Your ref: Docket Number 52-006  
Our ref: DCP\_NRC\_002874

May 21, 2010

**Subject: Final Information on Proposed Changes for the AP1000 Design Control Document Rev. 18**

Figure 5.4-7

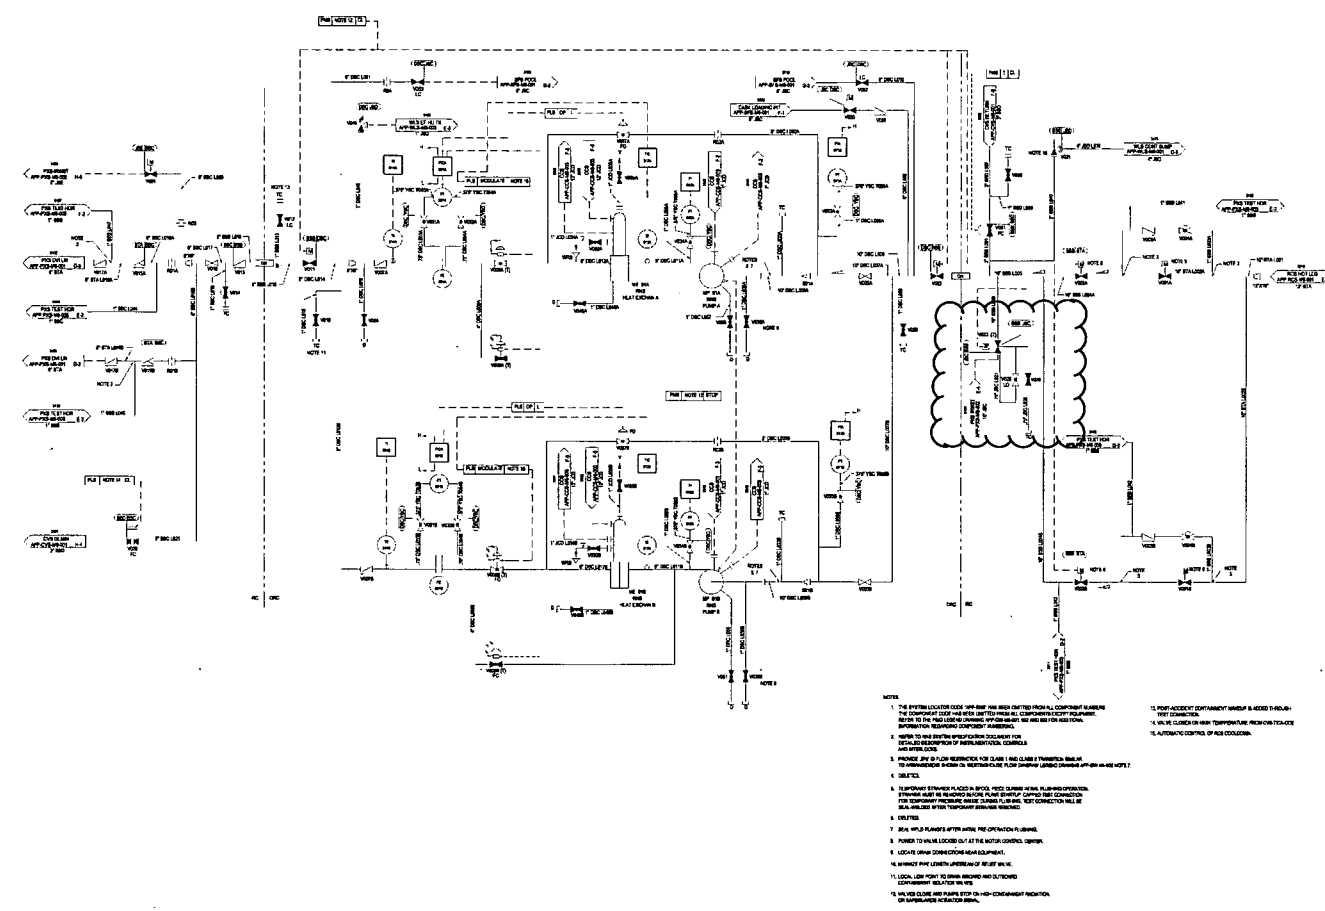
Change Number	Tier	Chapter Number	Section/Table/ Figure Numbers	Description of DCD Change	Description of Design Change	Applicable Regulatory Standard that Design Meets	Assessment of NRC Review Resources
1	Reported in DCP_NRC_002850 (4/26/2010)						
2	2	3	Table 3.2-3 (Sh 30/68)	AP1000 Classification of Mechanical and Fluid Systems, Components, and Equipment-add info on affected valves RNS-PL-V025/V026.			Medium
			Table 3.9-16 (Shs 14,15,23/23)	Add Containment Isolation Leak Test to IST Type and Frequency column. Delete Note 16.			
			Table 3-11-1 (Sh 41/50)	Environmentally Qualified Electrical and Mechanical Equipment-add info on affected valves RNS-PL-V025/V026			
		5	Table 3I.6-3 (Sh 21/31)	Add info on RNS-PL-V025/V026 to table			
		6	Figure 5.4-7	RNS P&ID-add detail of changes to affected valves RNS-PL-V025/V026 to figure.			
		6	Table 6.2.3-1 (Sh 2, 4/4)	Containment Mechanical Penetrations and Isolation Valves – add info on valves RNS-PL-V002A/B. Delete Note 6.

Figure 6.3-2

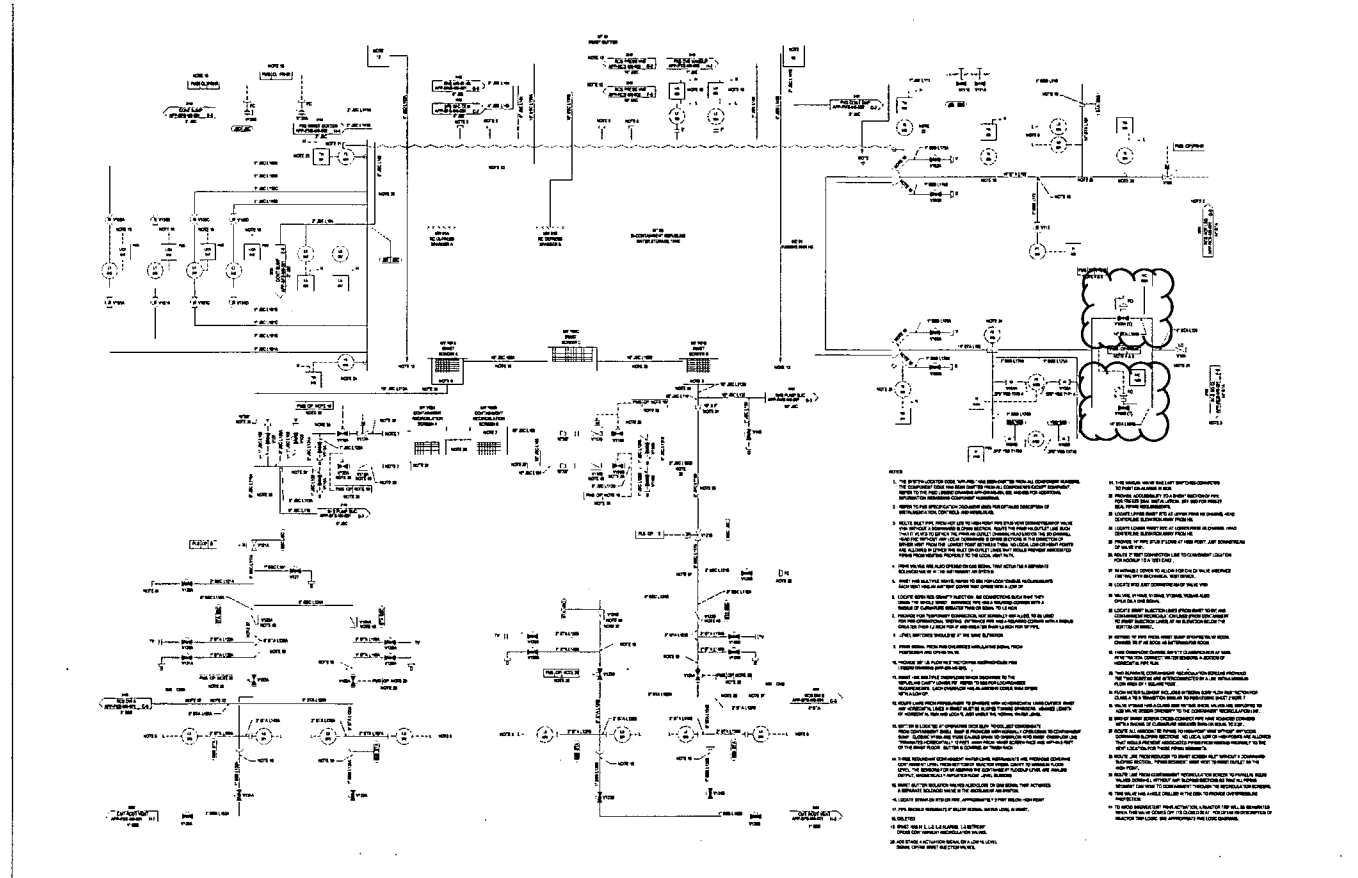
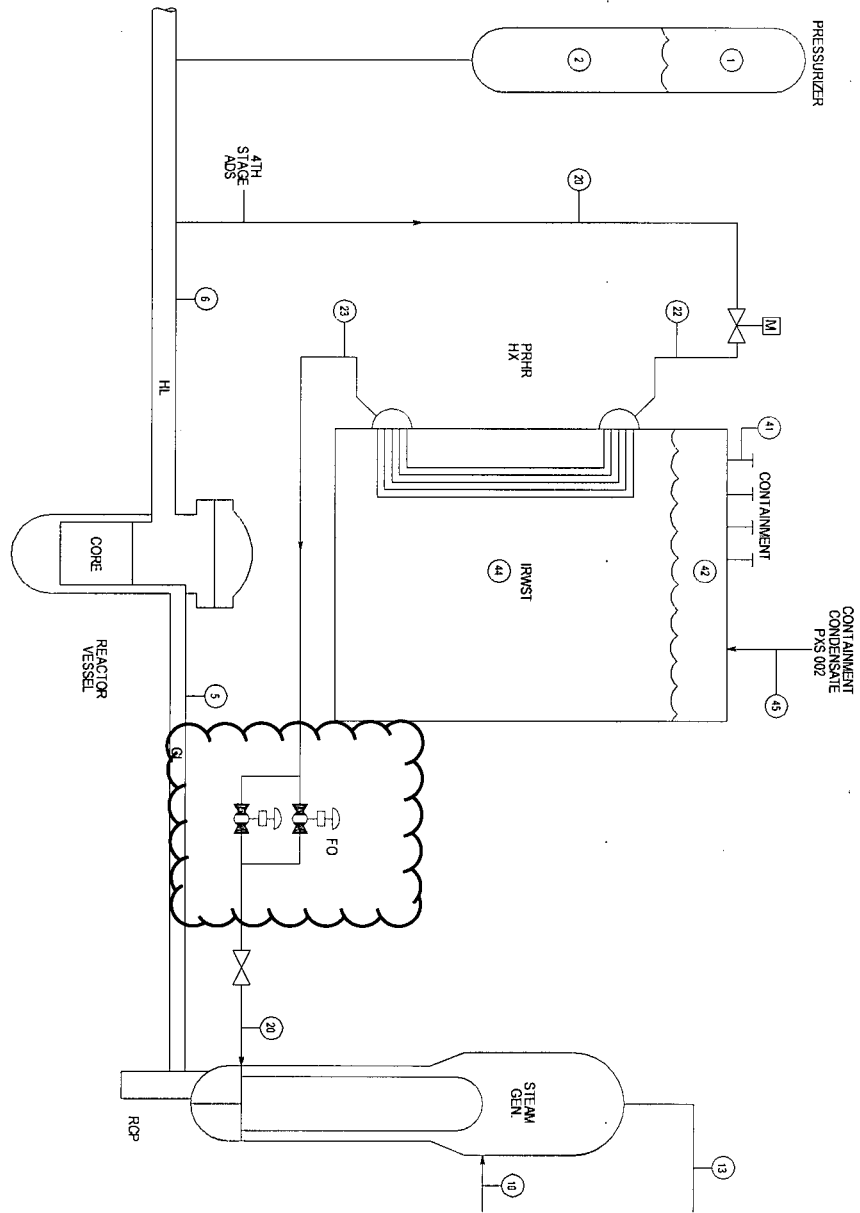
3	2	3	Table 3.9-16 (Sheet 10/23)	V0180A/B was changed from globe to ball valve.	The valve was changed from a globe valve to a ball valve.	ASME Boiler and Pressure Vessel Code, Section III - Class 1	Medium
		6	Section 6.3.2.1.2 Figure 6.3-2 Figure 6.3-4	See Enclosure 8, Action Item 9.

Figure 6.3-2

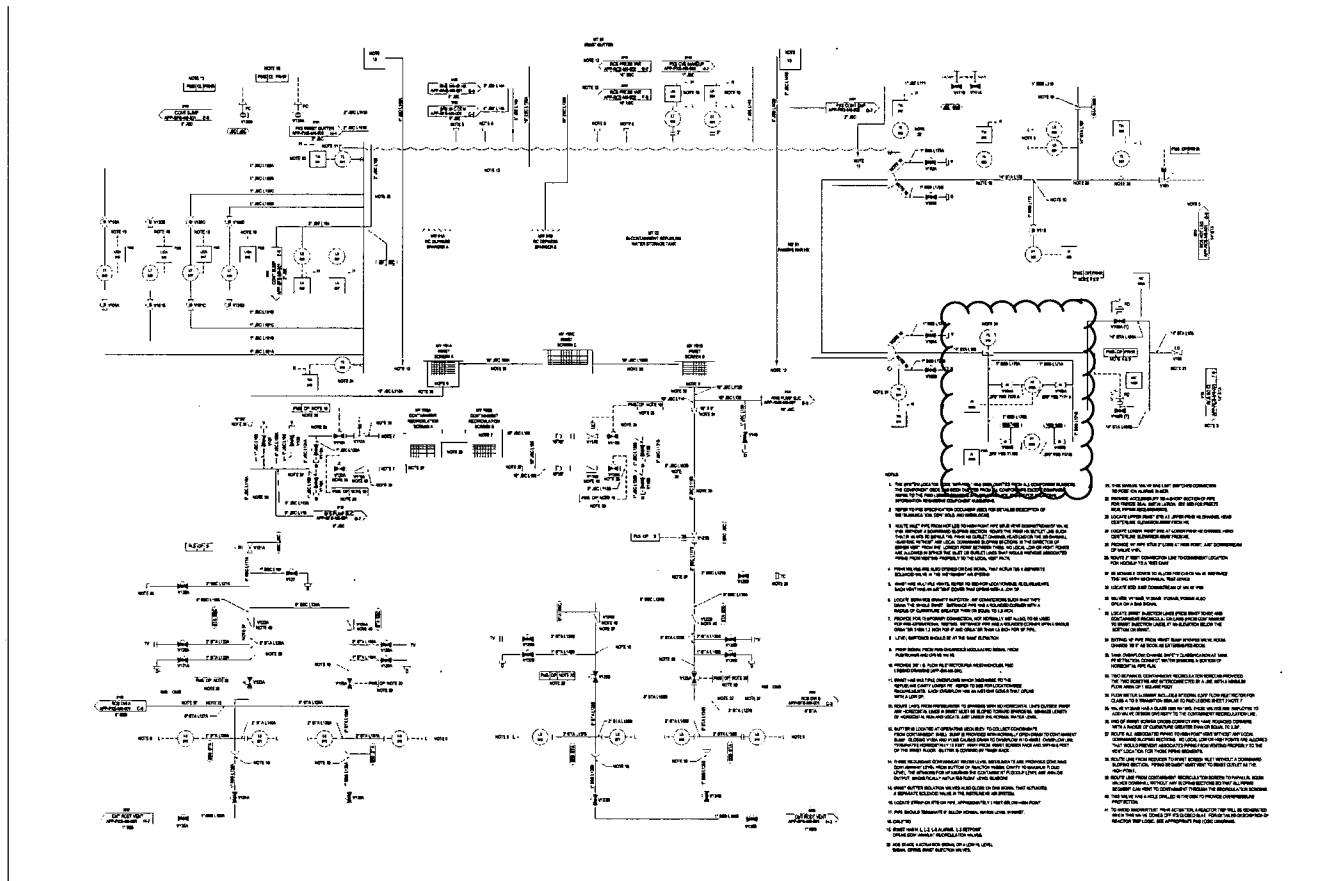
6	Section 6.3.2.2.8.1	Delete sentence describing check valves. This sentence had described all check valves as either piston type or swing type which is no longer true.				
			Section 6.3.7.6.1	Revise valve position indication description.				
			Section 6.3.7.6.2	Delete last sentence because there is no reference to Chapter 7 in Table 6.3-1.				
			Figure 6.3-1	Revise PXS P&ID				
			Table 6.3-3 (sh 1/4)	Revise entry for CMT discharge line check valves.				
5	Reported in DCP_NRC_002850 (4/26/2010)							
6	Reported in DCP_NRC_002850 (4/26/2010)							
7	2	6	Figure 6.3-2 (sh 2)	Change of position for the PRHR HX flow meter			Medium

Figure 3.8.3-8 (Sheet 3 of 3)

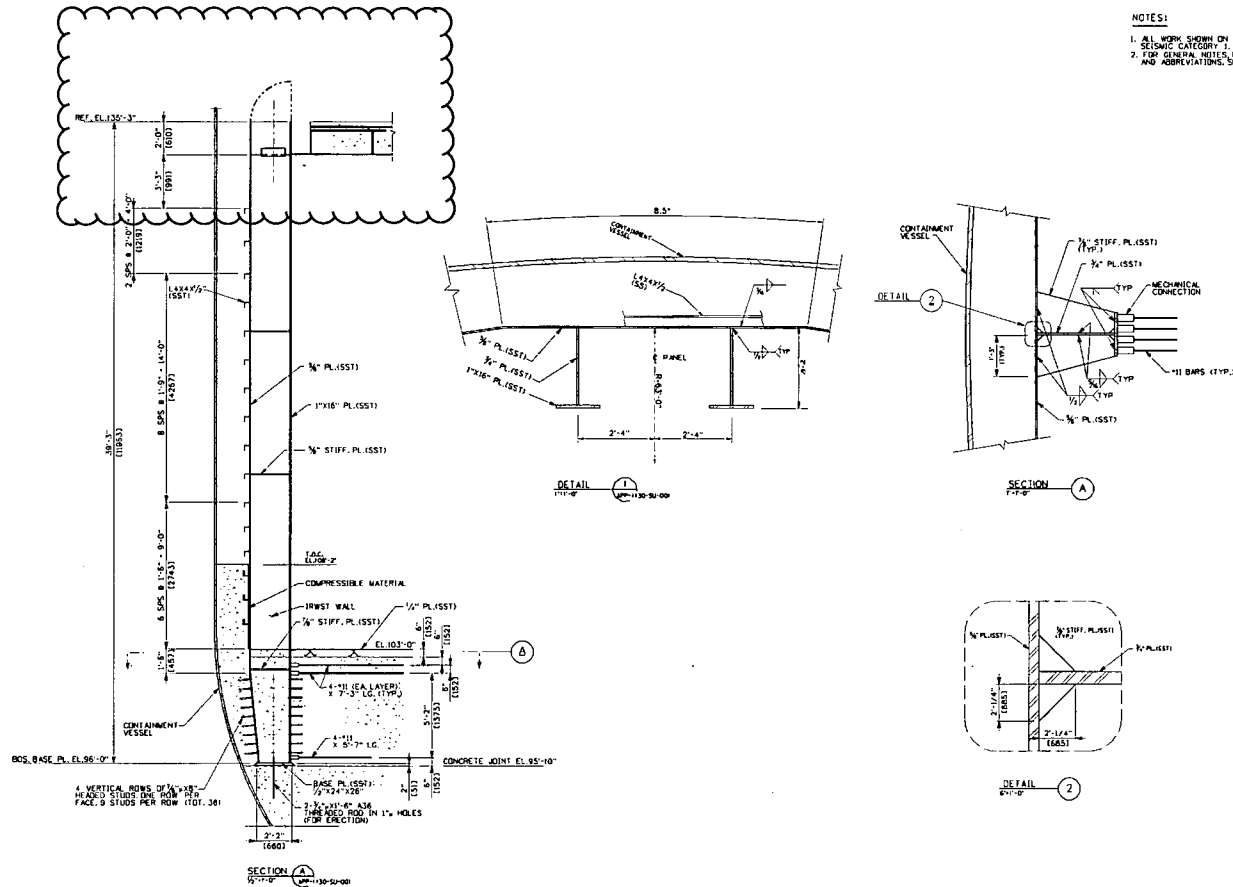
41	2*	3	Figure 3.8.3-8 (Sheet 3/3)	Modify Plant Module Bolted Connection			Low
42	2	1	Section 1.9.5.1.11	The normal operating pressure is shown as 2250 psig and it should be 2250 psia.  See Enclosure 8, Action Item 7.			Low
43	2	1	Section 1.7	Text was provided on Interpretation of figures in Tier 2.			Low
